## **Staff Changes**

This section covers changes proposed by Planning Staff to correct errors and to reflect changes in conversion philosophy based on discussions with the PHED Committee and the Planning Board.

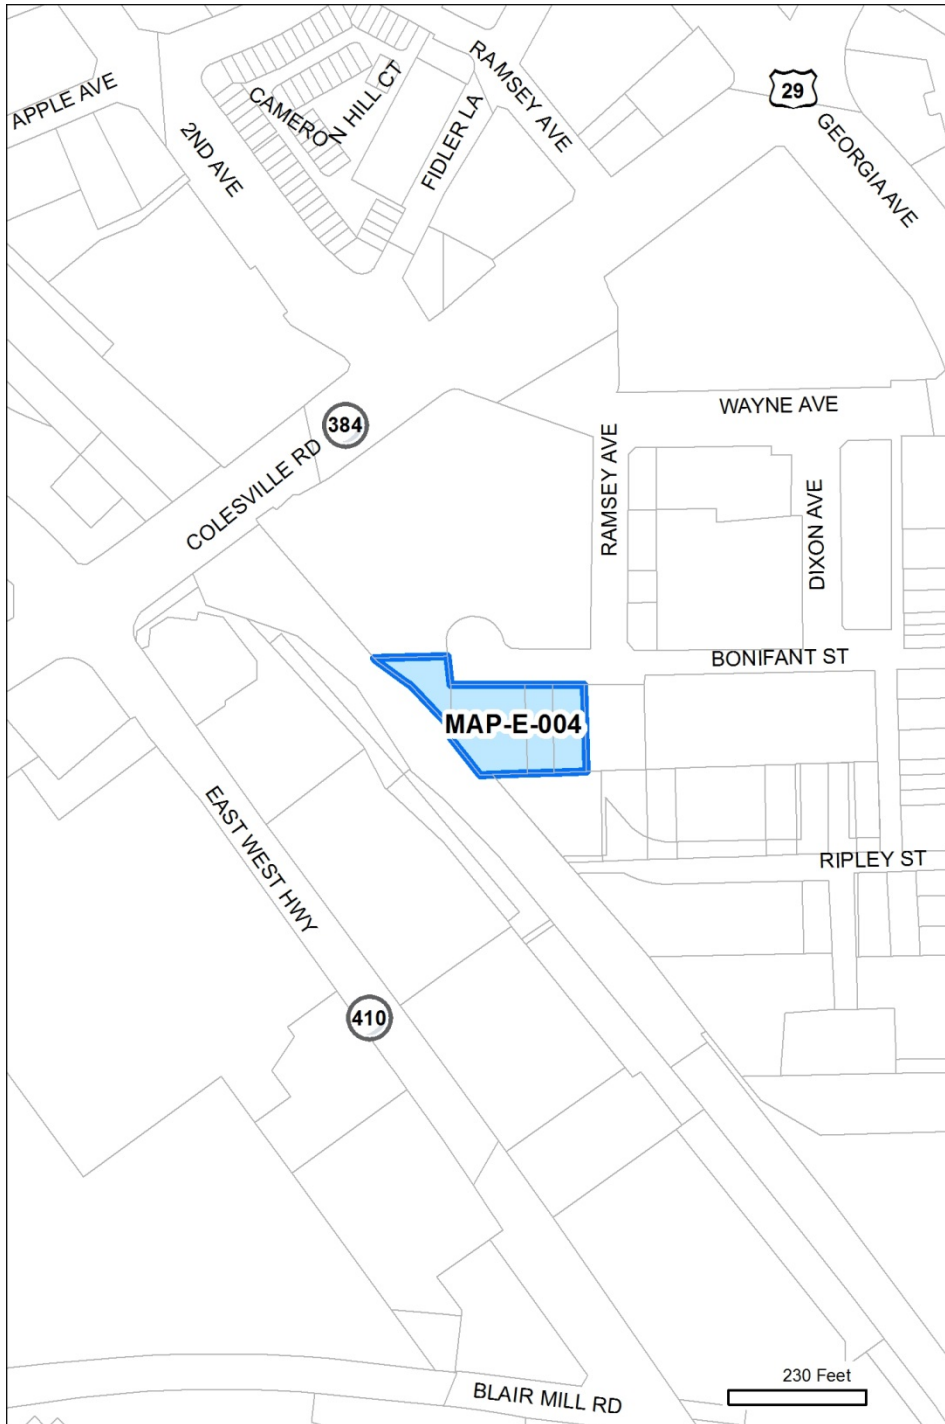
<b>Unique ID:</b> MAP-E-001		staff rec. change
<b>Master Plan ID:</b> n/a		
<b>Master Plan:</b>	Fairland	
<b>Location:</b>	Saddlecreek Drive	
<b>Existing Zone:</b>	R-200	
<b>Proposed Conv:</b> (5/2)	R-200 / PD-2	
<b>Prop. Revised Conv:</b>	R-200	
<b>Category:</b>	Staff Error	
<b>Modifications</b>	<b>Zone Group:</b>	No change / Corrected to R-200
	<b>Overall FAR:</b>	-
	<b>Comm'l FAR:</b>	-
	<b>Resid'l FAR:</b>	-
	<b>Height:</b>	-
<b>Reason for change:</b>		
An error in the GIS layer showed portions of this site as being zoned PD-2. That was in error. The site should be entirely R-200.

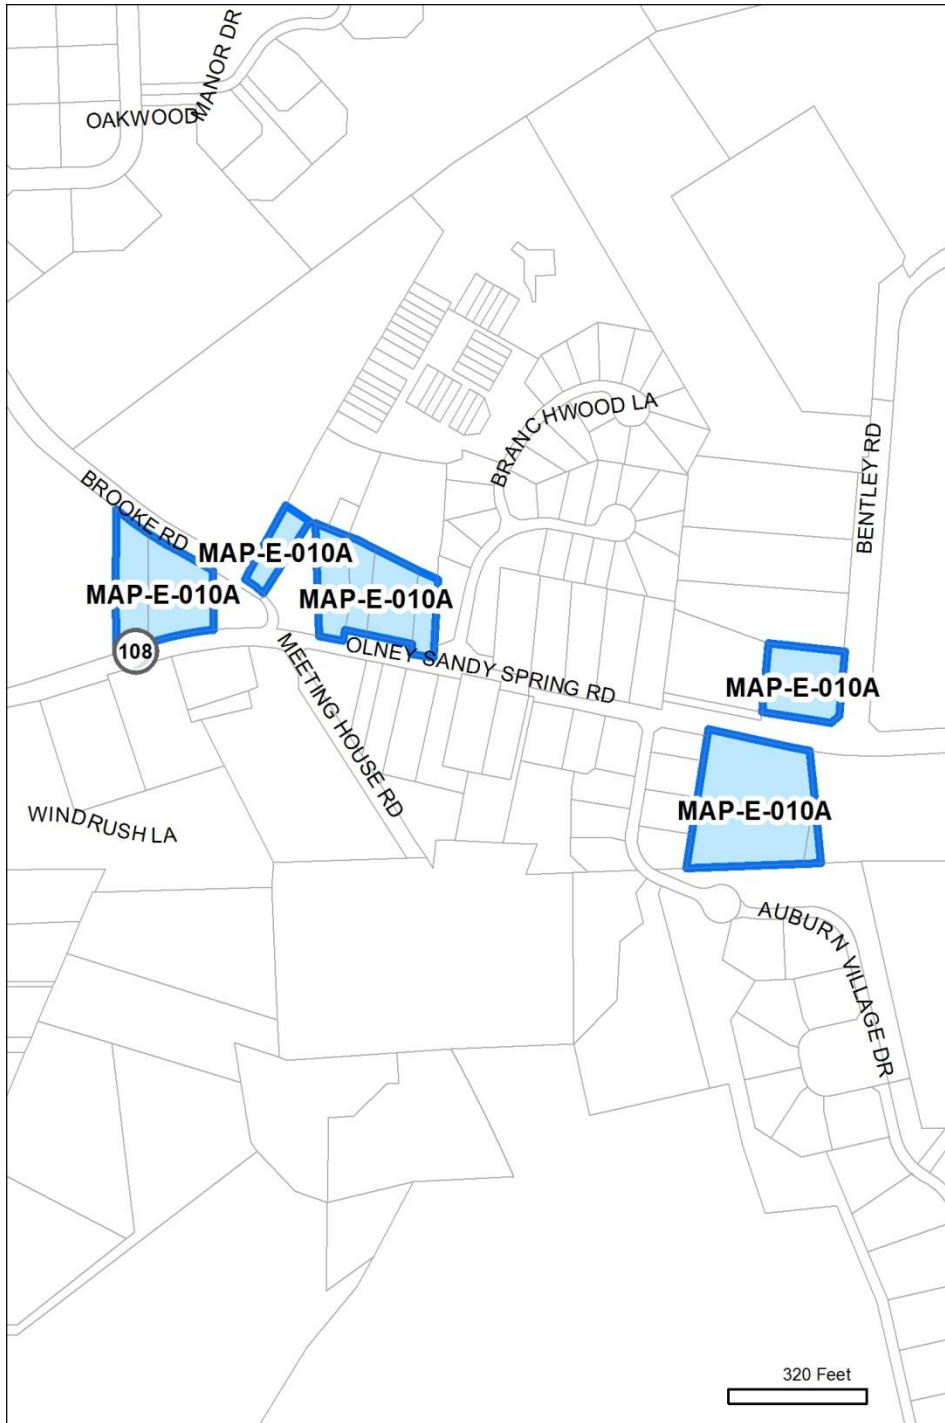
<b>Unique ID:</b> MAP-E-010A		staff rec. change
<b>Master Plan ID:</b> 1		
<b>Master Plan:</b>	Sandy Spring/Ashton	
<b>Location:</b>	Sandy Spring and Ashton village centers	
<b>Existing Zone:</b>	C-2	
<b>Proposed Conv:</b> (5/2)	CRT-1.0 C-0.75 R-0.5 H-35	
<b>Prop. Revised Conv:</b>	CRT-1.5 C-0.75 R-0.75 H-35	
<b>Category:</b>	Staff Error	
<b>Modifications</b>	<b>Zone Group:</b>	No change
	<b>Overall FAR:</b>	Increased to 1.5
	<b>Comm'l FAR:</b>	No change
	<b>Resid'l FAR:</b>	Increased to 0.75
	<b>Height:</b>	No change
<b>Reason for change:</b>		
<p><i>This C-2 property is in the Sandy Spring/Ashton Rural Village Overlay. It should have been given the revised standard conversion for C-2 abutting medium density residential, but staff did not catch the change in this case.</i></p> <p><i>The standard conversion for C-2 abutting medium density residential is CRT-1.5 C-1.5 R-0.75 H-45. However, this formula must be modified by the restrictions of the Overlay Zone.</i></p> <p><i>The Overlay restricts height to 30'. It restricts commercial FAR to 0.75.</i></p>

<b>Notes:</b>		
<p><i>Height only reduced to 35' because that's the minimum height for the CRT zone.</i></p>

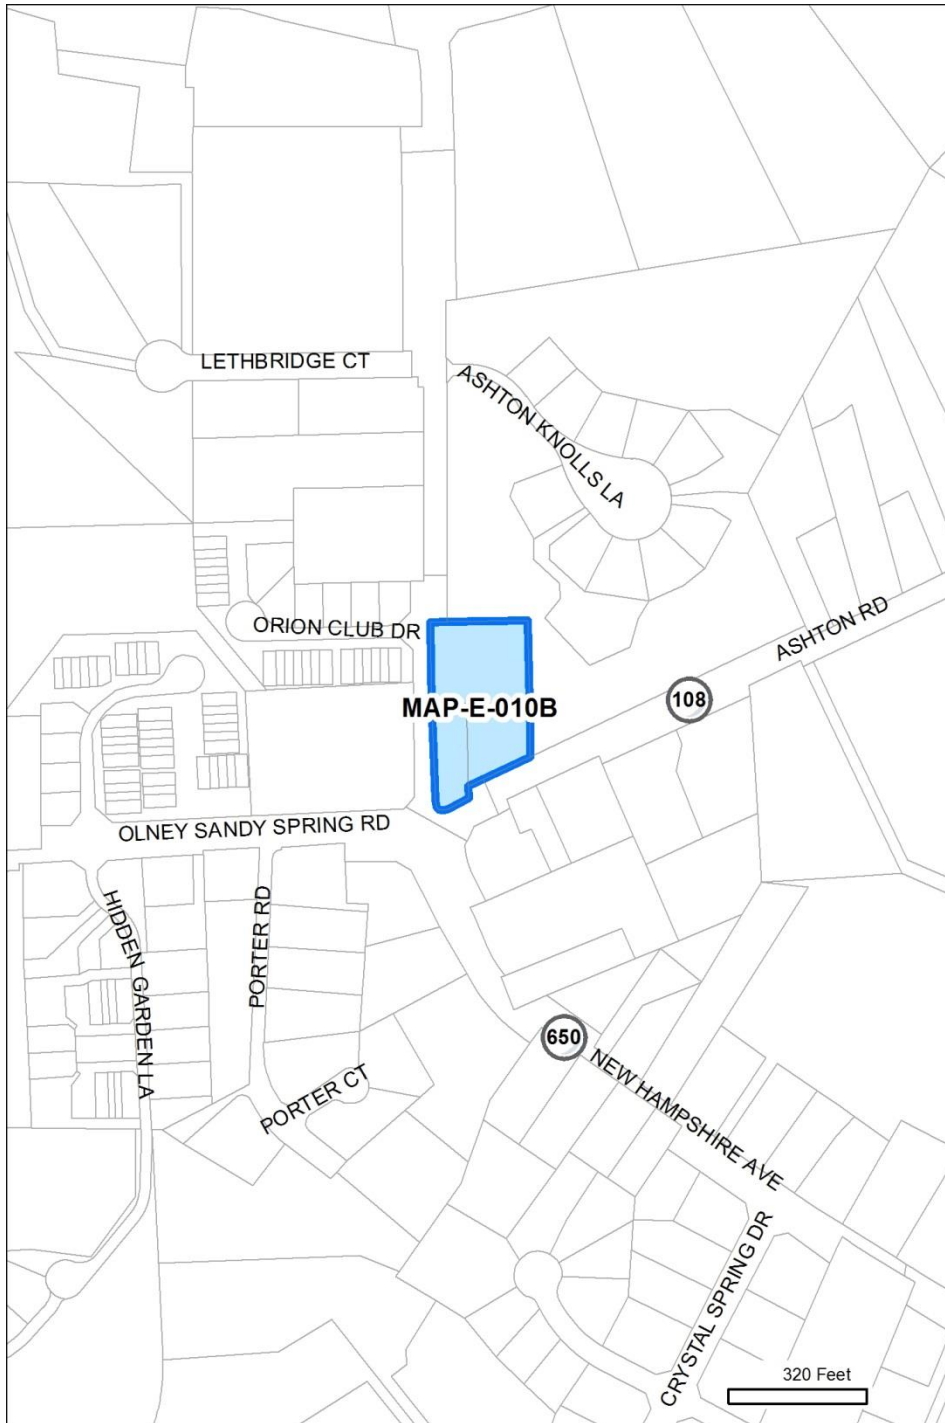
<b>Unique ID:</b> MAP-E-010B		staff rec. change
<b>Master Plan ID:</b> 1		
<b>Master Plan:</b>	Sandy Spring/Ashton	
<b>Location:</b>	Sandy Spring and Ashton village centers	
<b>Existing Zone:</b>	C-2	
<b>Proposed Conv:</b> (5/2)	CRT-1.0 C-0.75 R-0.5 H-35	
<b>Prop. Revised Conv:</b>	CRT-1.5 C-0.75 R-0.75 H-35	
<b>Category:</b>	Staff Error	
<b>Modifications</b>	<b>Zone Group:</b>	No change
	<b>Overall FAR:</b>	Increased to 1.5
	<b>Comm'l FAR:</b>	No change
	<b>Resid'l FAR:</b>	Increased to 0.75
	<b>Height:</b>	No change
<b>Reason for change:</b>		
<p><i>This C-2 property is in the Sandy Spring/Ashton Rural Village Overlay. It should have been given the revised standard conversion for C-2 abutting medium density residential, but staff did not catch the change in this case.</i></p> <p><i>The standard conversion for C-2 abutting medium density residential is CRT-1.5 C-1.5 R-0.75 H-45. However, this formula must be modified by the restrictions of the Overlay Zone.</i></p> <p><i>The Overlay restricts height to 30'. It restricts commercial FAR to 0.75.</i></p>

<b>Notes:</b>		
<p><i>Height only reduced to 35' because that's the minimum height for the CRT zone.</i></p>

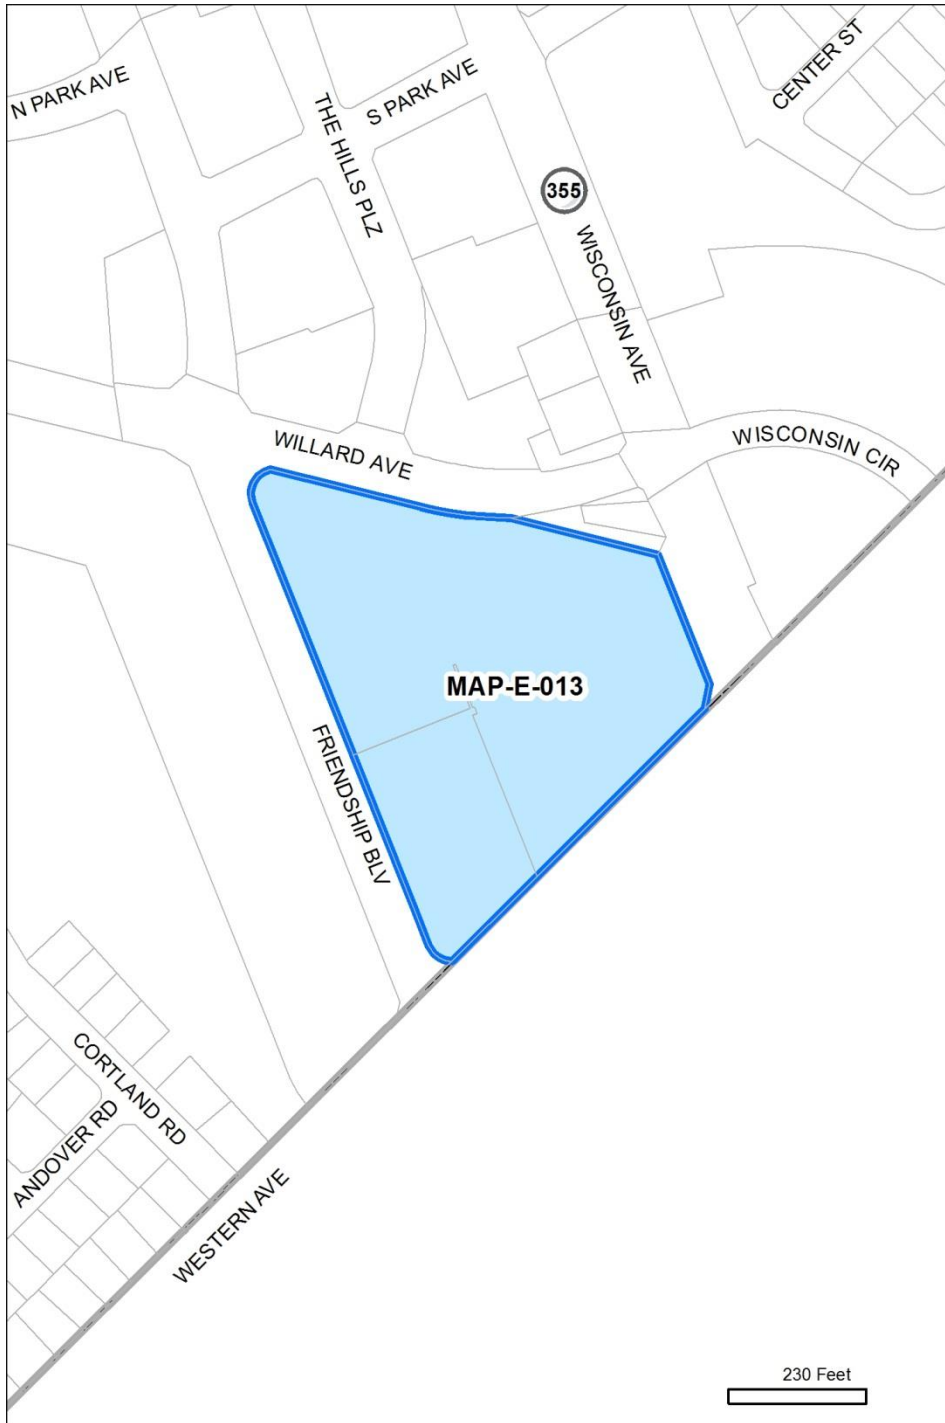
<b>Unique ID:</b> MAP-E-013		staff rec. change
<b>Master Plan ID:</b> 3		
<b>Master Plan:</b>	Friendship Heights	
<b>Location:</b>	Bounded by Wisc, Western, Willard, and Friendship	
<b>Existing Zone:</b>	CBD-2	
<b>Proposed Conv:</b> (5/2)	<del>CR-3.0 C-2.5 R-1.5 H-90 T</del>	
<b>Prop. Revised Conv:</b>	CR-3.0 C-2.75 R-0.5 H-145 T	
<b>Category:</b>	Staff Error	
<b>Modifications</b>	<b>Zone Group:</b>	No change
	<b>Overall FAR:</b>	No change
	<b>Comm'l FAR:</b>	Increased to 2.75
	<b>Resid'l FAR:</b>	Reduced to 0.5
	<b>Height:</b>	Increased to 145'
<b>Reason for change:</b>		
<p><i>The 5/2 conversion was made in error. The existing zoning was mislabeled as CBD-1. However, the default conversion needs to be for the CBD-2 zone. This increases the height to 145', the default height. The Master Plan is silent on height.</i></p> <p><i>The overall, commercial, and residential FARs are set by the square footage limits indicated in the master plan recommendations below. (PHED Committee recommendation)</i></p>

<b>Notes:</b>		
<p><i>Master Plan limits development to 1,050,000 square feet [3.03 FAR]. Limits commercial to 940,000 square feet [2.7 FAR]. Limits residential to 150,000 square feet [0.4 FAR].</i></p>

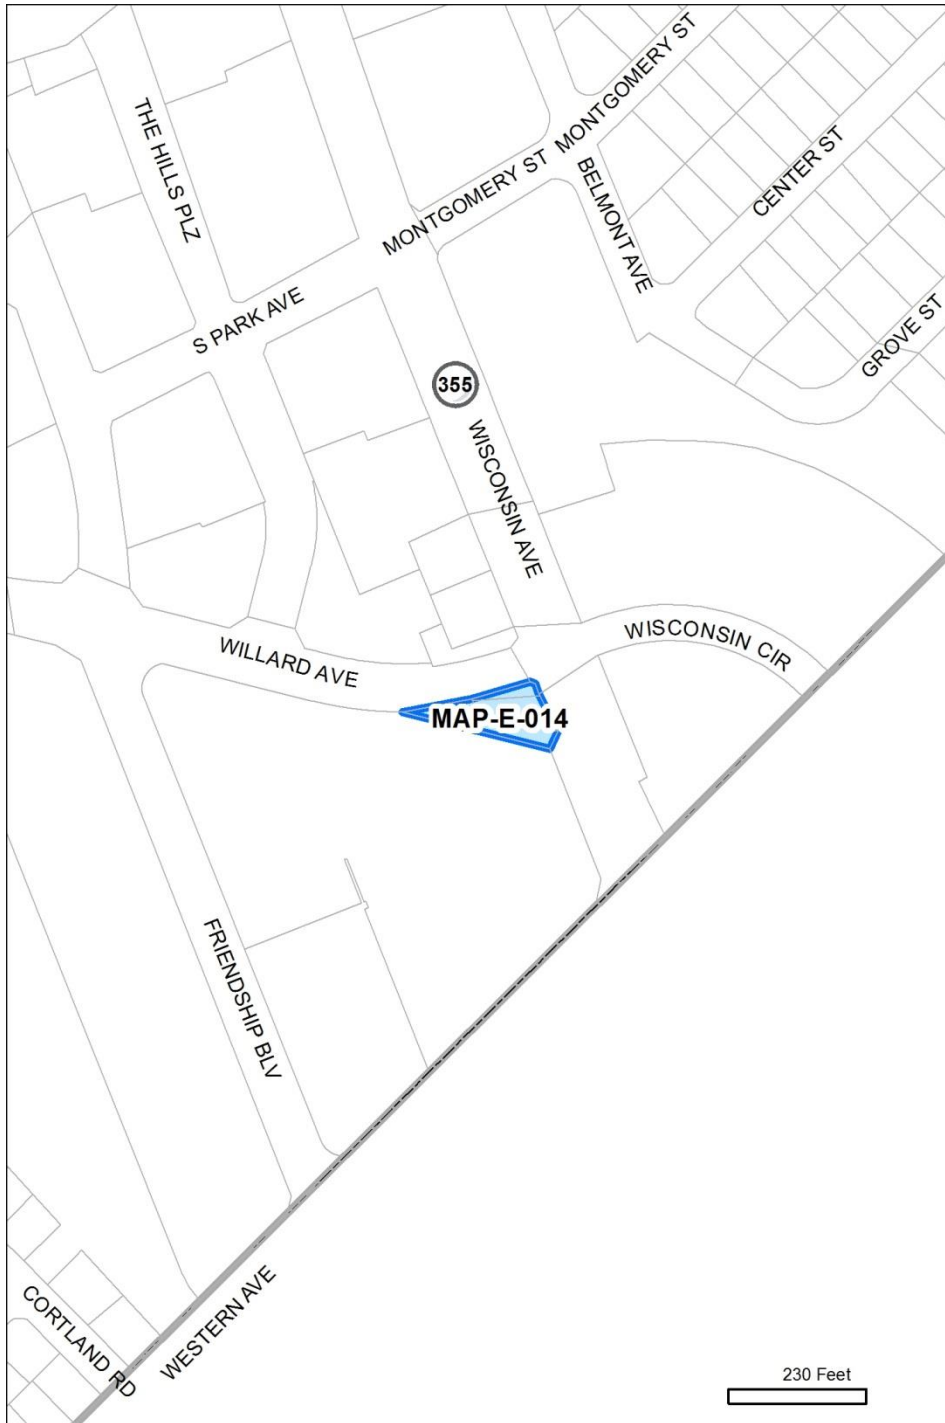
<b>Unique ID:</b> MAP-E-014		staff rec. change
<b>Master Plan ID:</b> 3		
<b>Master Plan:</b>	Friendship Heights	
<b>Location:</b>	SW corner Wisconsin and Willard	
<b>Existing Zone:</b>	CBD-2	
<b>Proposed Conv: (5/2)</b>	<del>CR-3.0 C-2.0 R-2.5 H-90 T</del>	
<b>Prop. Revised Conv:</b>	CR-5.0 C-3.0 R-4.5 H-145 T	
<b>Category:</b>	Staff Error	
<b>Modifications</b>	<b>Zone Group:</b>	No change
	<b>Overall FAR:</b>	Increased to 5.0
	<b>Comm'l FAR:</b>	Increased to 3.0
	<b>Resid'l FAR:</b>	Increased to 4.5
	<b>Height:</b>	Increased to 145'
<b>Reason for change:</b>		
<p><i>The 5/2 conversion was made in error. The existing zoning was mislabeled as CBD-1. However, the default conversion needs to be for the CBD-2 zone. This increases the components of the formula, as the Master Plan is silent.</i></p>

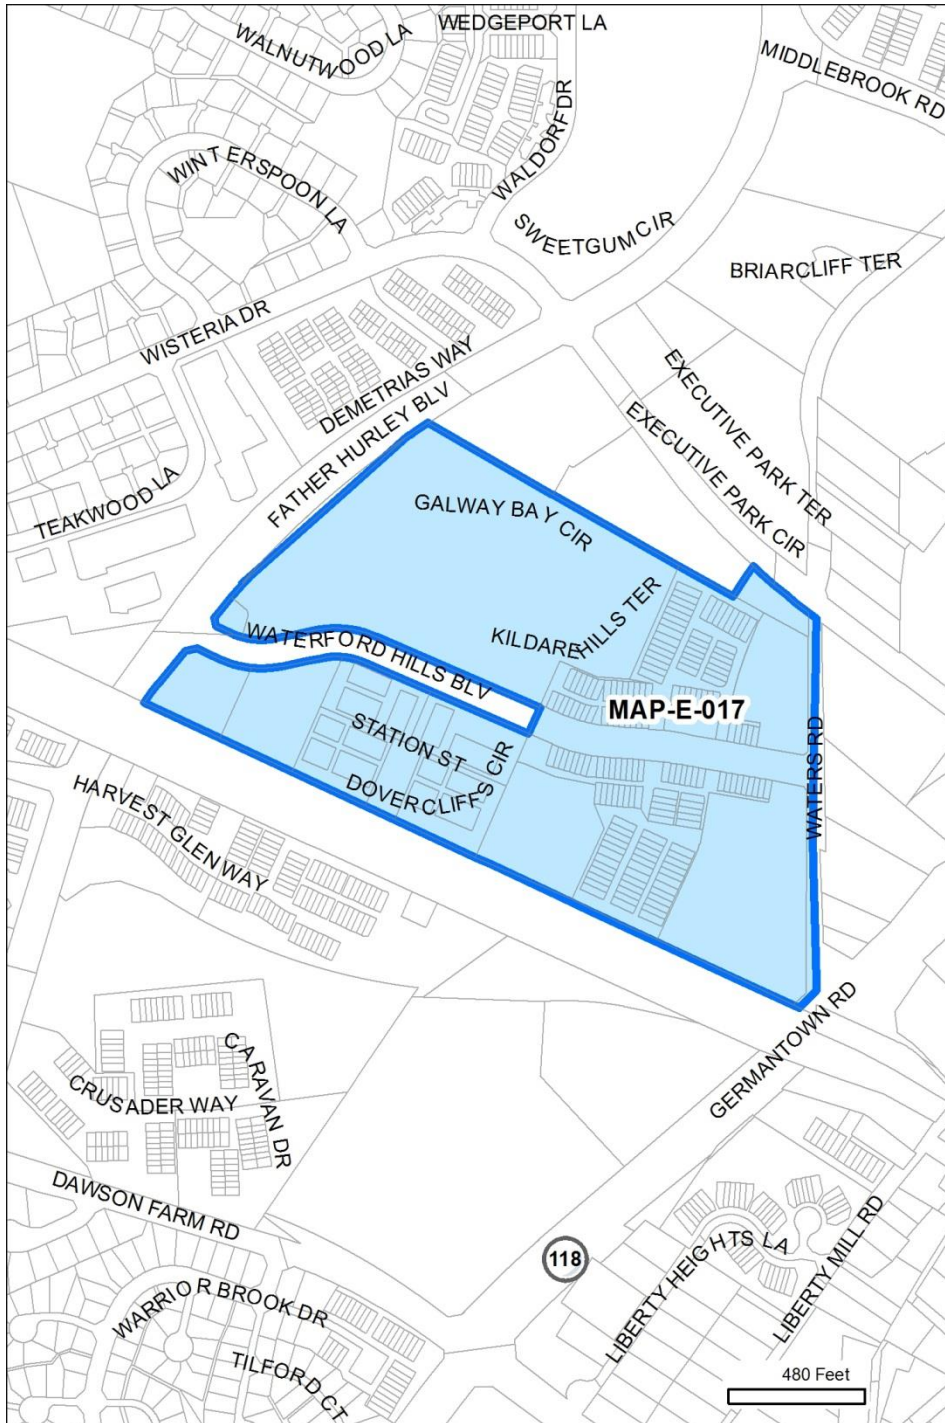
<b>Unique ID:</b> MAP-E-017		staff rec. change
<b>Master Plan ID:</b> 18		
<b>Master Plan:</b>	Germantown Town Center	
<b>Location:</b>	West of Waters Road south of Wisteria	
<b>Existing Zone:</b>	RMX-2	
<b>Proposed Conv:</b> (5/2)	CRT-1.0 C-0.5 R-0.75 H-60 T	
<b>Prop. Revised Conv:</b>	CRT-1.0 C-0.25 R-0.75 H-65 T	
<b>Category:</b>	Staff Error	
<b>Modifications</b>	<b>Zone Group:</b>	No change
	<b>Overall FAR:</b>	No change
	<b>Comm'l FAR:</b>	Reduced to 0.25
	<b>Resid'l FAR:</b>	No change
	<b>Height:</b>	Increased to 65'
<b>Reason for change:</b>		
<p>The Master Plan recommends limiting commercial FAR to 0.17. The 5/2 conversion gave a commercial FAR of 0.5 (the default conversion for the zone). This should be changed to 0.25 to be closer to the Master Plan recommendation.</p> <p>The Master Plan is silent on height. As a result, the default (65') should be given instead of 60'.</p>

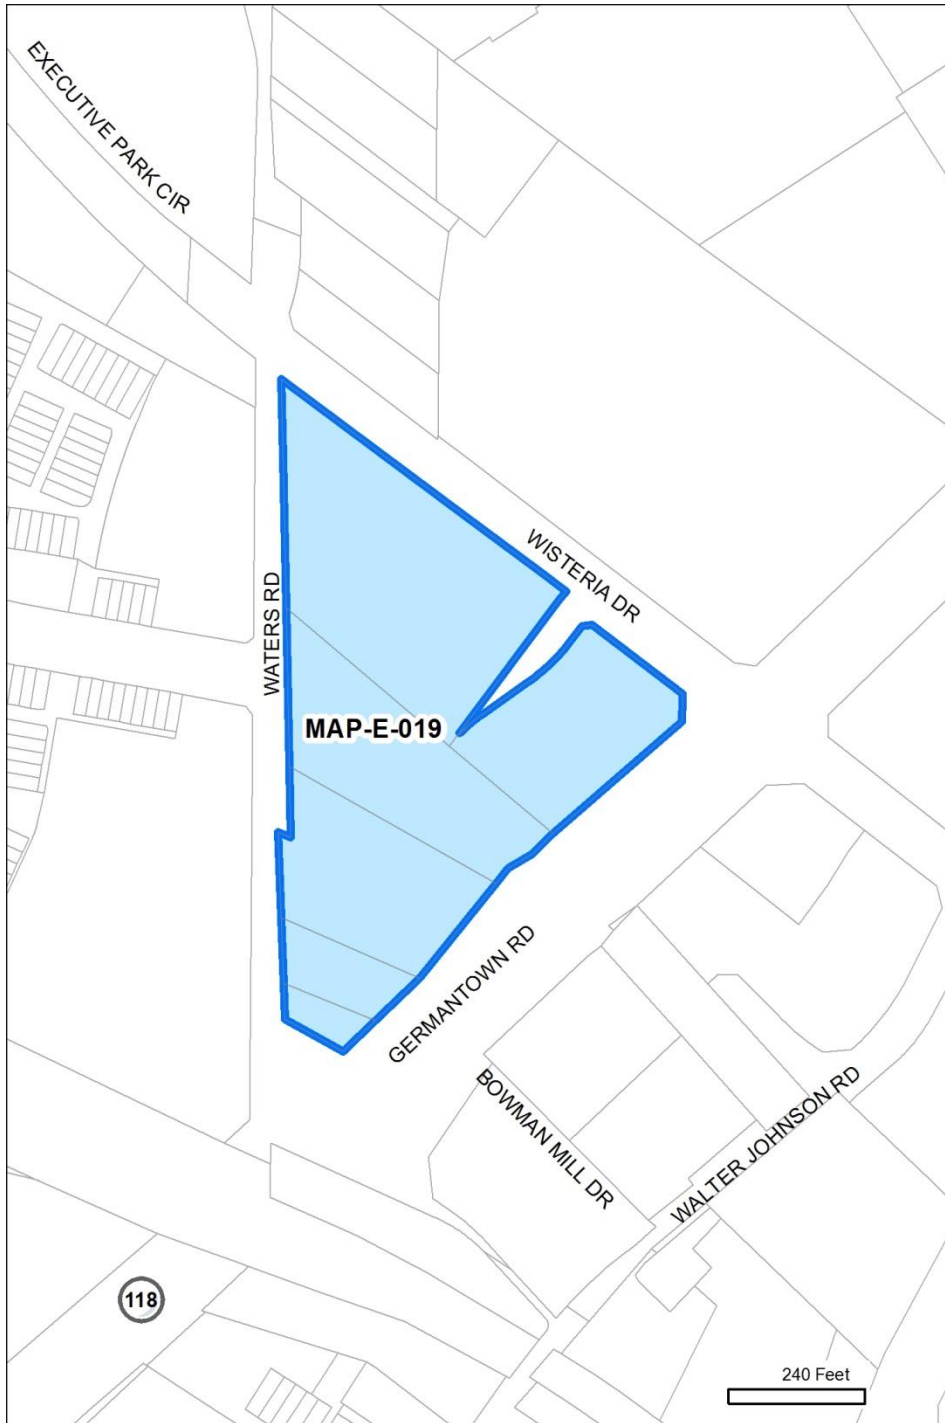
<b>Unique ID:</b> MAP-E-019		staff rec. change
<b>Master Plan ID:</b> 19		
<b>Master Plan:</b>	Germantown Town Center	
<b>Location:</b>	Triangle bounded by Waters Rd, Wisteria, Germantown Rd	
<b>Existing Zone:</b>	RMX-2C	
<b>Proposed Conv:</b> (5/2)	<del>CRT-1.0 C-0.5 R-0.75 H-60 T</del>	
<b>Prop. Revised Conv:</b>	CRT-1.0 C-0.25 R-0.75 H-65 T	
<b>Category:</b>	Staff Error	
<b>Modifications</b>	<b>Zone Group:</b>	No change
	<b>Overall FAR:</b>	No change
	<b>Comm'l FAR:</b>	Reduced to 0.25
	<b>Resid'l FAR:</b>	No change
	<b>Height:</b>	Increased to 65'
<b>Reason for change:</b>		
<p><i>The Master Plan recommends limiting commercial FAR to 0.17. The 5/2 conversion gave a commercial FAR of 0.5 (the default conversion for the zone). This should be changed to 0.25 to be closer to the Master Plan recommendation.</i></p> <p><i>The Master Plan is silent on height. As a result, the default (65') should be given instead of 60'.</i></p>
